**THE CITY OF THE VILLAGE OF DOUGLAS
PLANNING COMMISSION MEETING
THURSDAY, JULY 11, 2024 AT 7:00 PM
86 W CENTER ST., DOUGLAS MI**

To: City of the Village of Douglas Planning Commission
Date: July 5, 2024
From: Sean Homyen, Planning & Zoning Administrator
RE: 319 Ferry St – Proposed Multi-Family Development

On behalf of the City of Douglas, our office has reviewed the *revised* drawings dated *June 12, 2024* and received *July 3, 2024* for the above referenced project. Our comments regarding the project are as follows: *A previous review was completed on March 11, 2024; the comments corresponding to this review are in blue italics.*

SHEET NO:
C-201

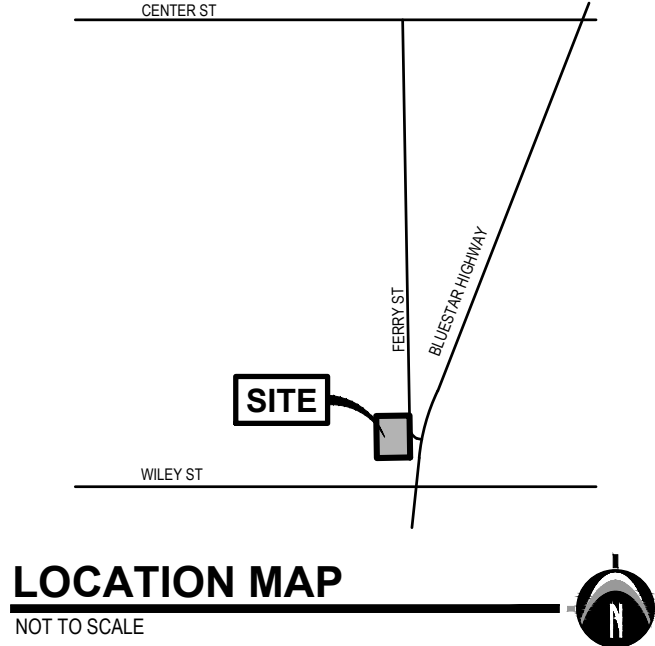
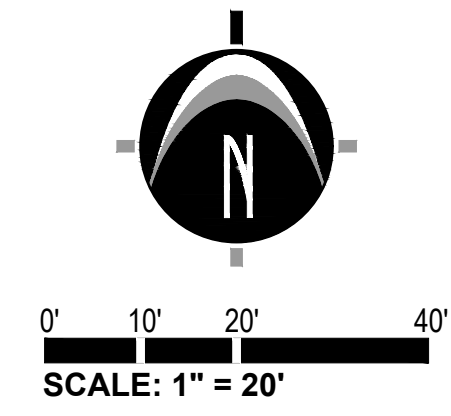
6. More information must be provided on the existing storm sewer to verify where the storm sewer is flowing. The City has limited records on the storm sewer. On C-201

SHEET NO:
C-203

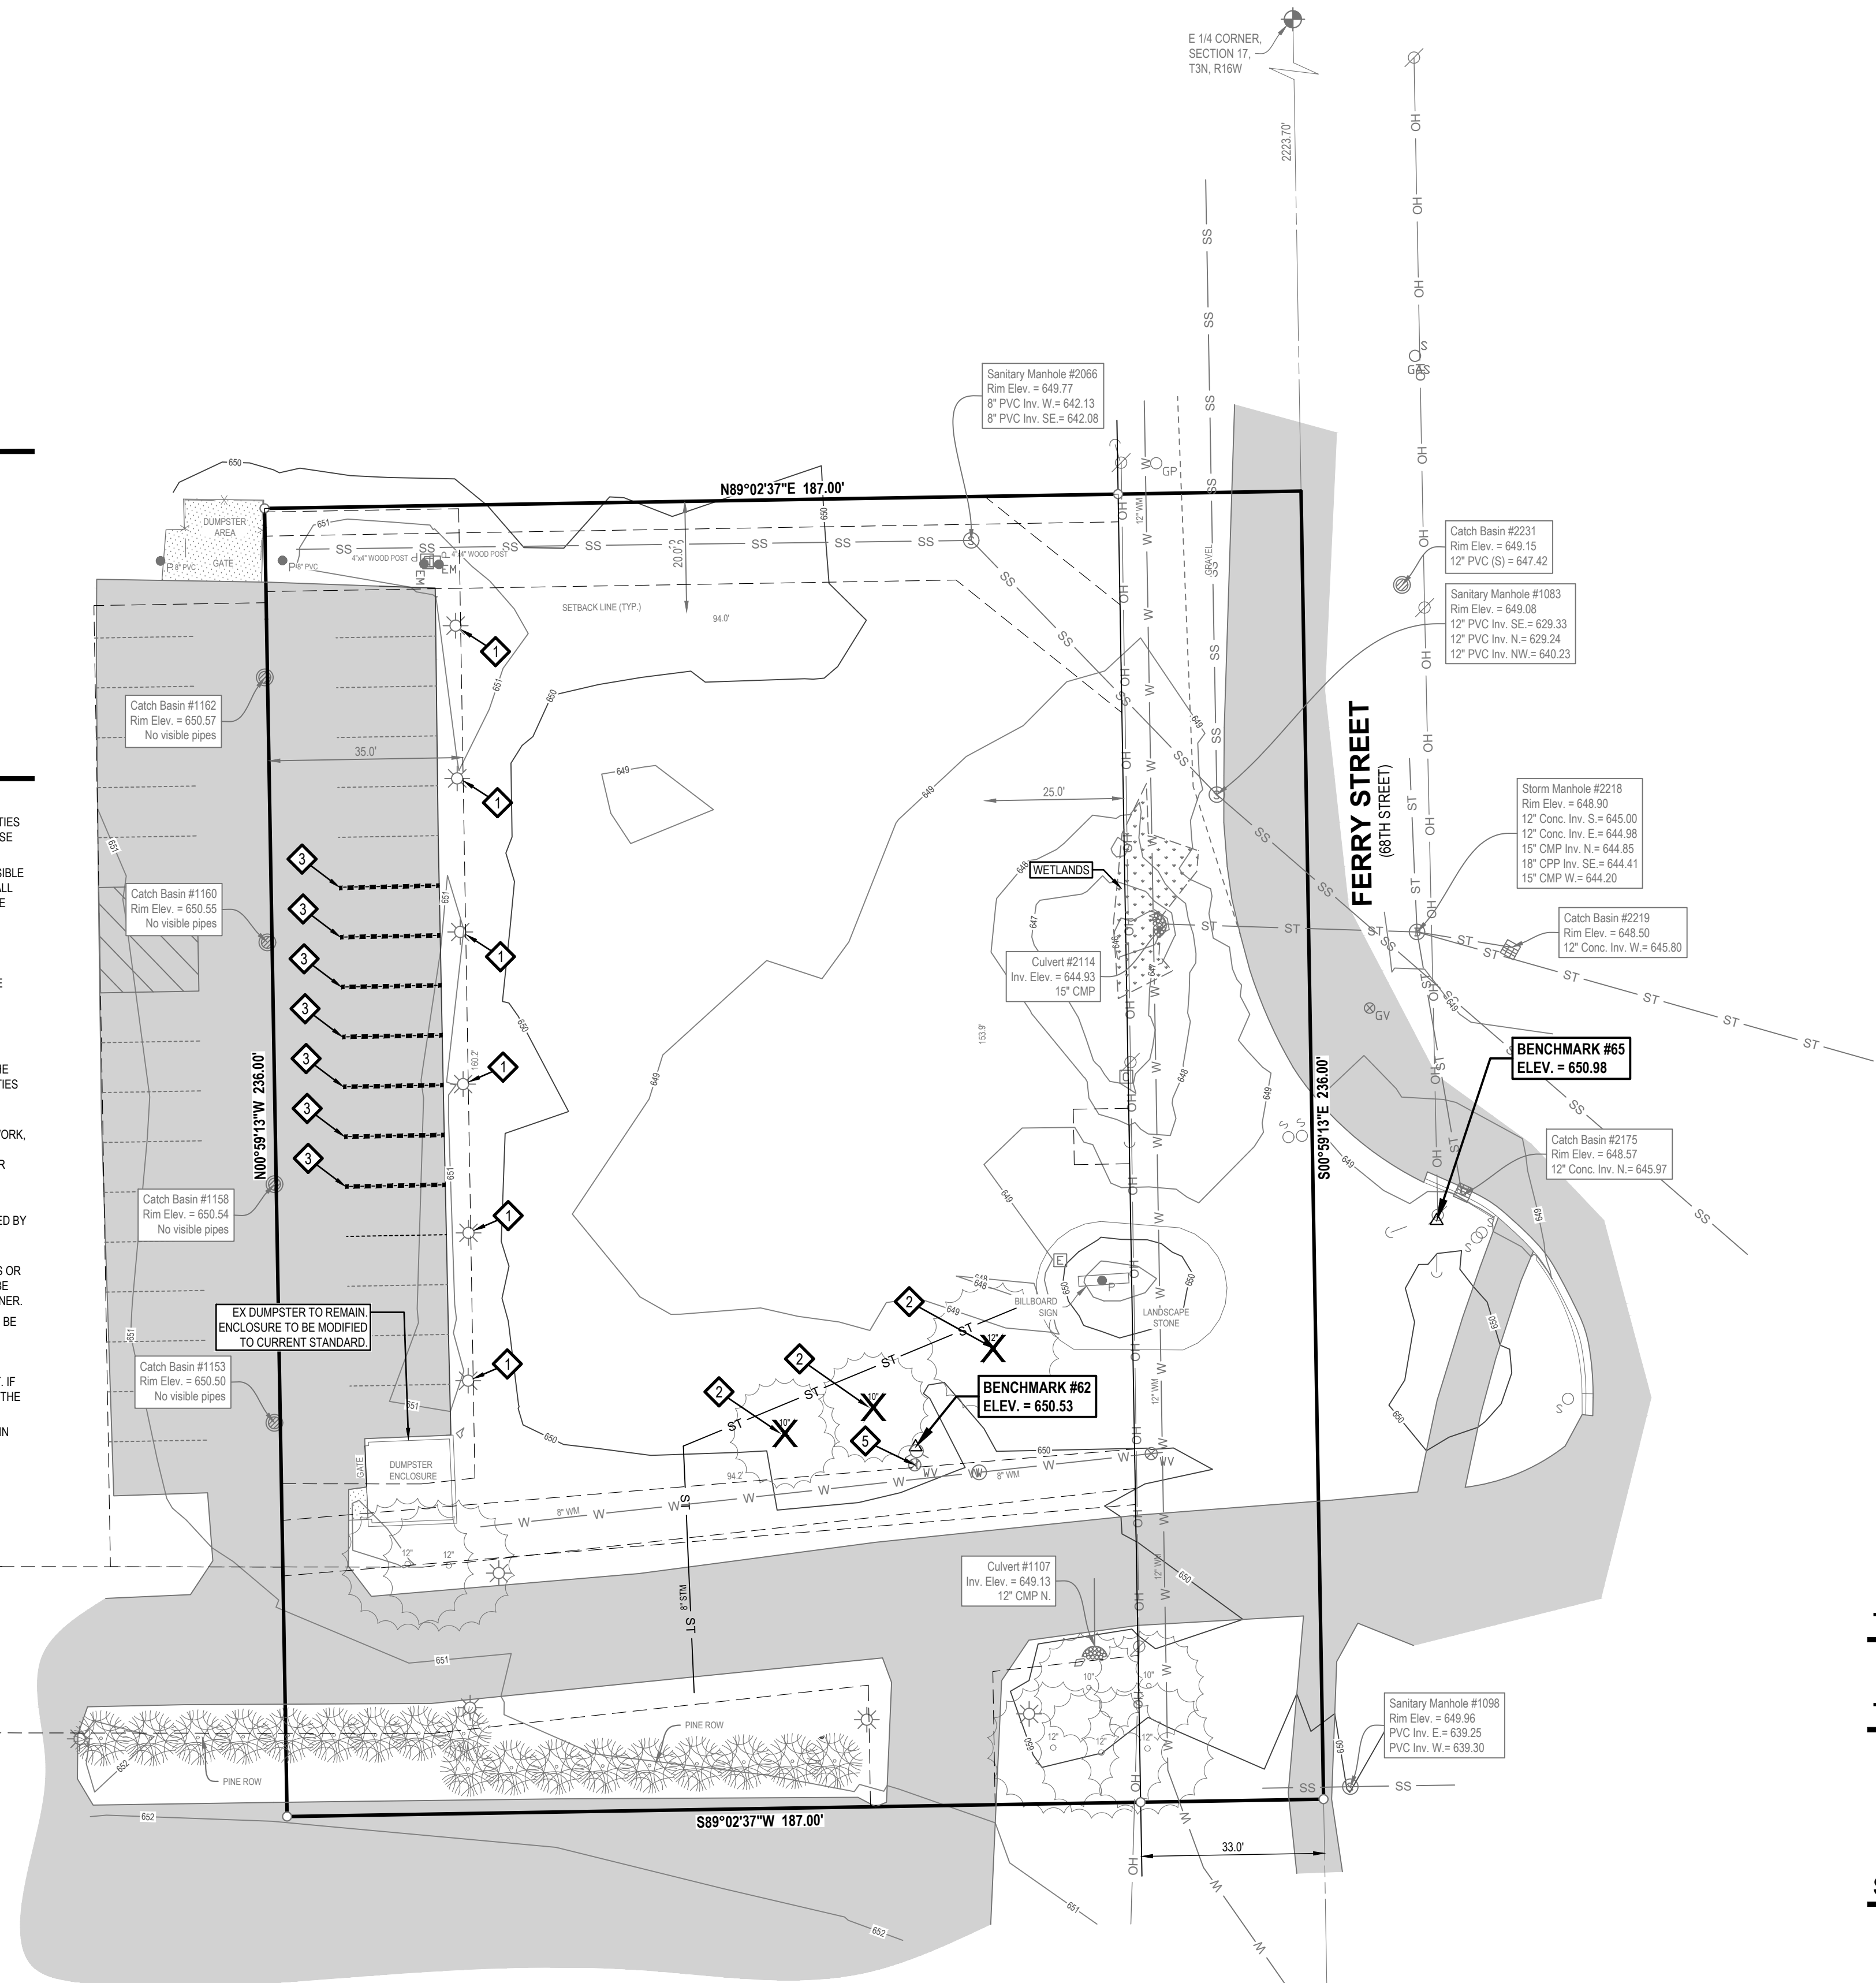
7. Please note that the storm sewer must be reviewed by Allegan County Drain Commission as noted in the submittal. Water quality will need to be added to the design. *There is storm sewer from the south that will need to be reviewed as part of ACDC’s review. (See C-203, two locations.)*

SHEET NO:
C-205

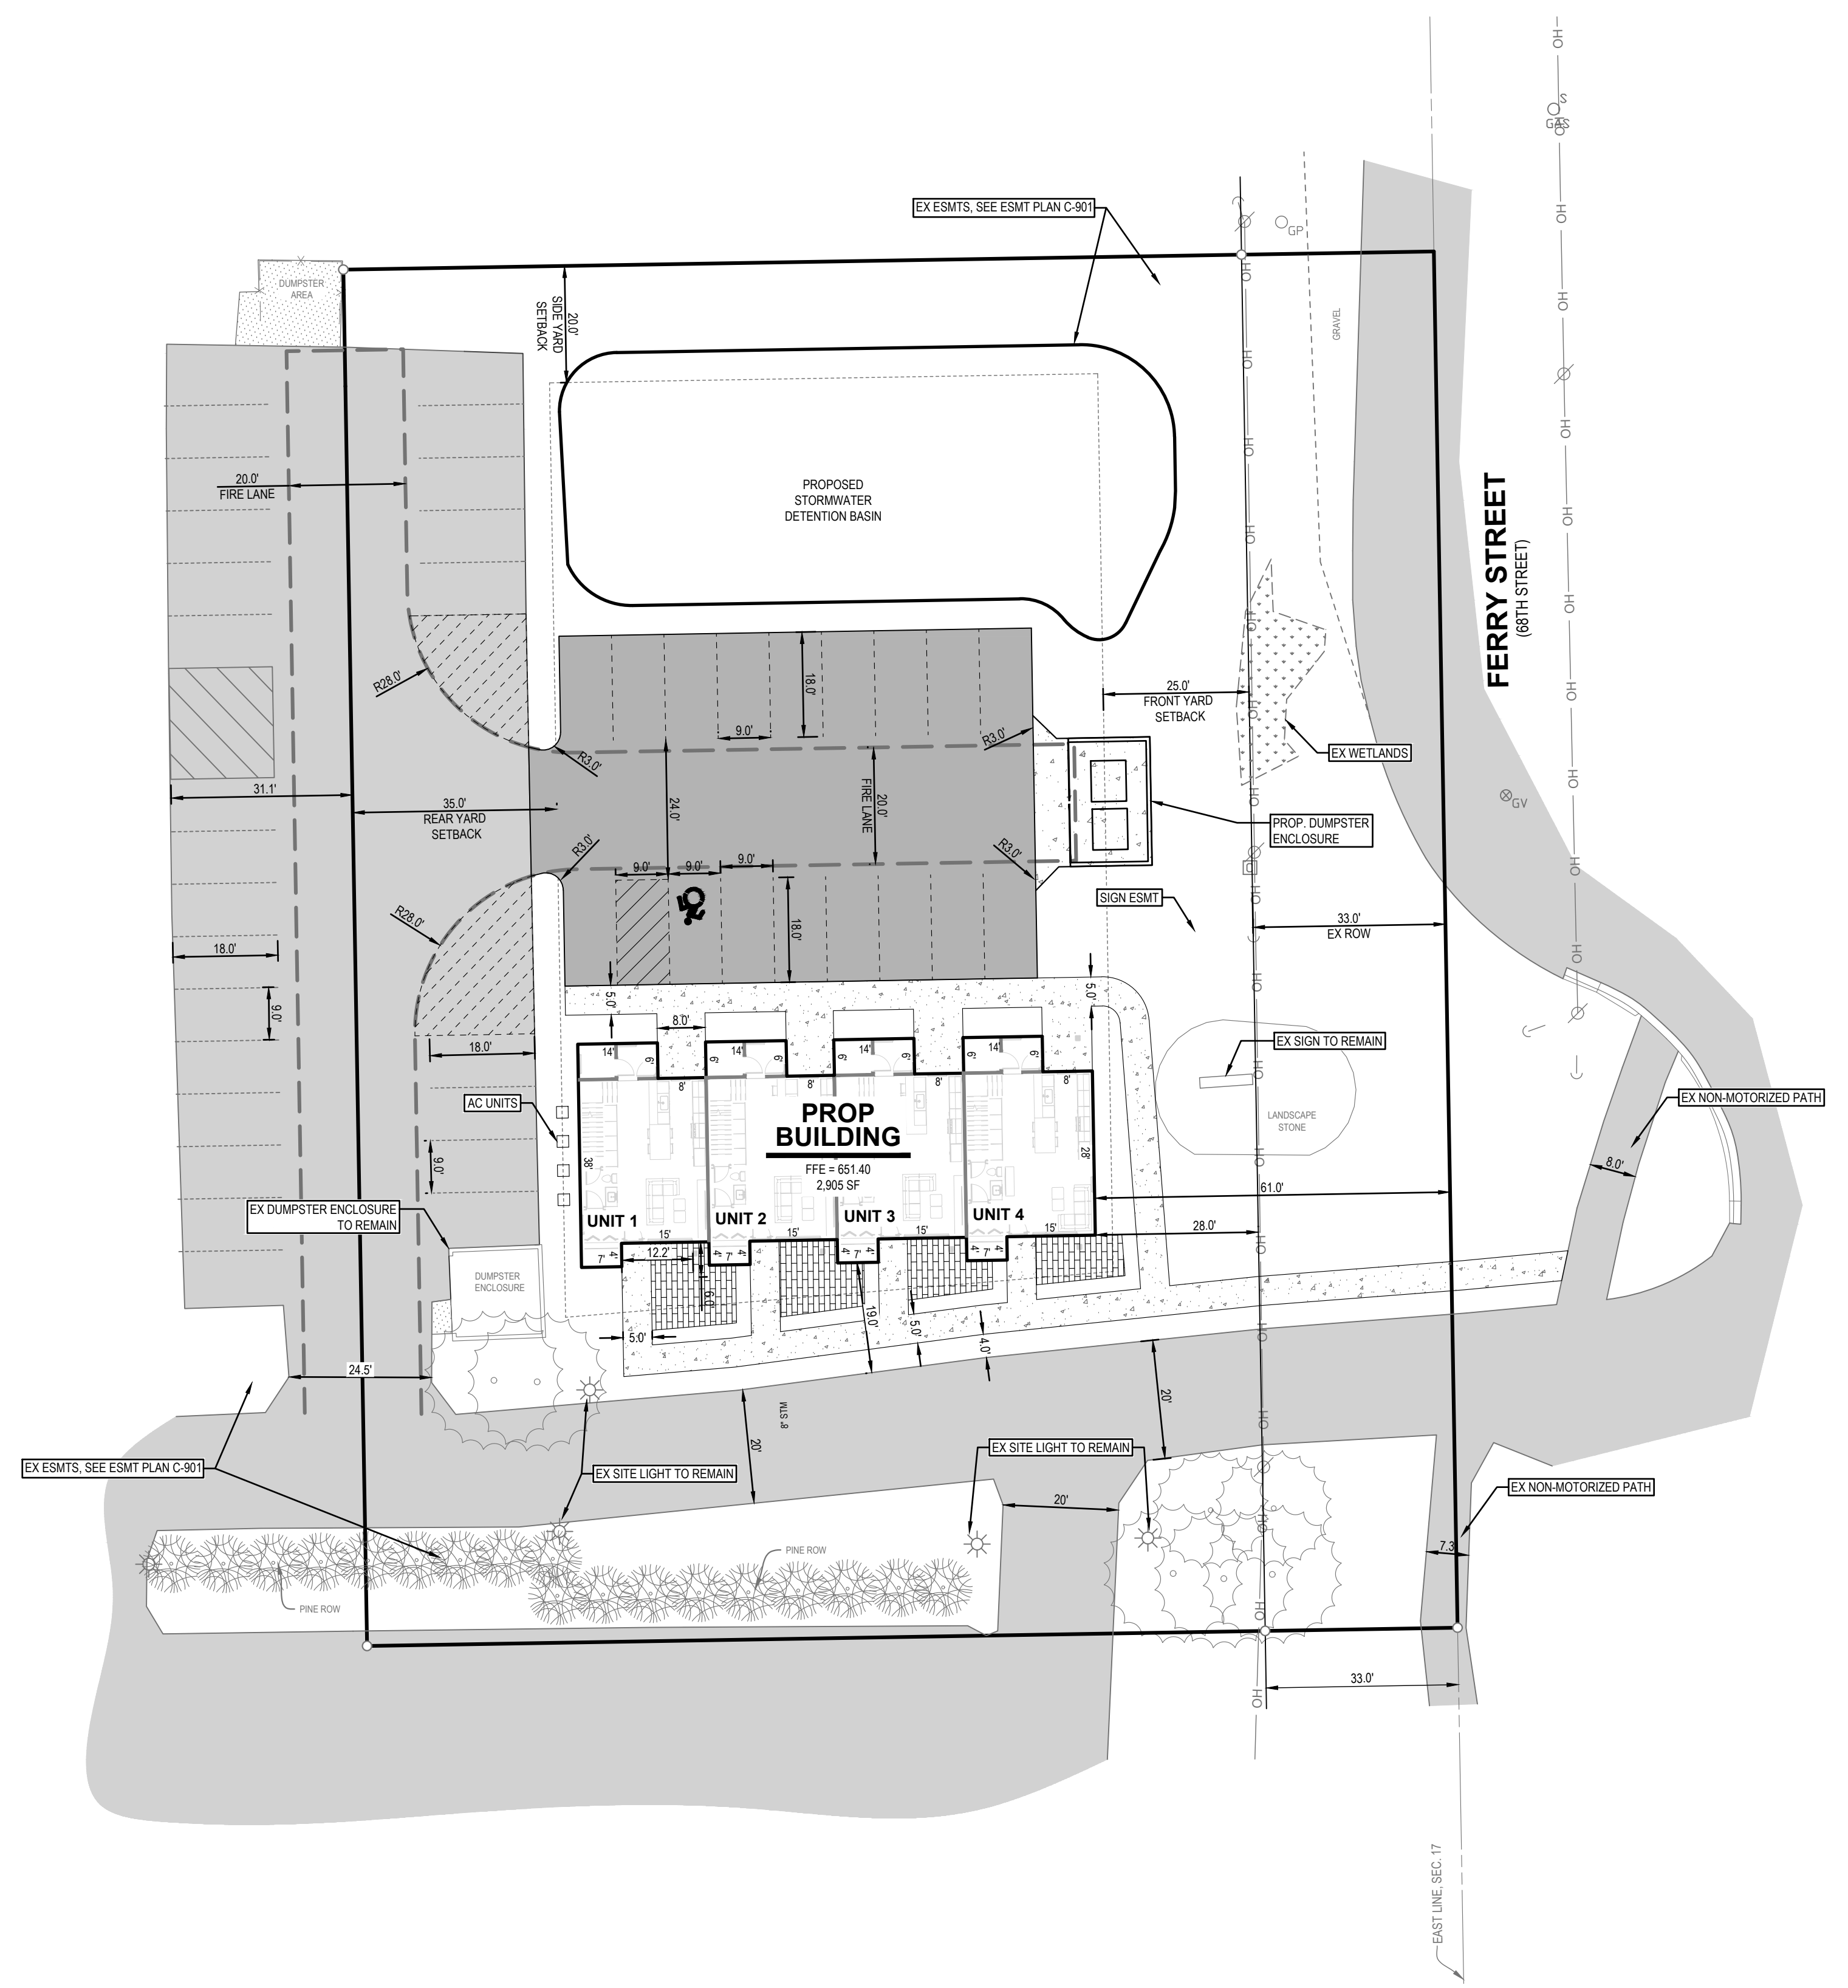
1. The proposed development includes a single *2905* square foot building containing *4* townhouse units on about 0.8 acre site.
2. Please identify on C-205 the width of the existing pavement of the driveway. Is there a way to improving the driveway access onto Blue Star Highway? Can an easement be obtained from the parcel to the north and connect to Ferry Street? *The width of the driveway is shown as 20 feet wide. Revisions were made to the site, and no plans are made to revise the driveway access.*
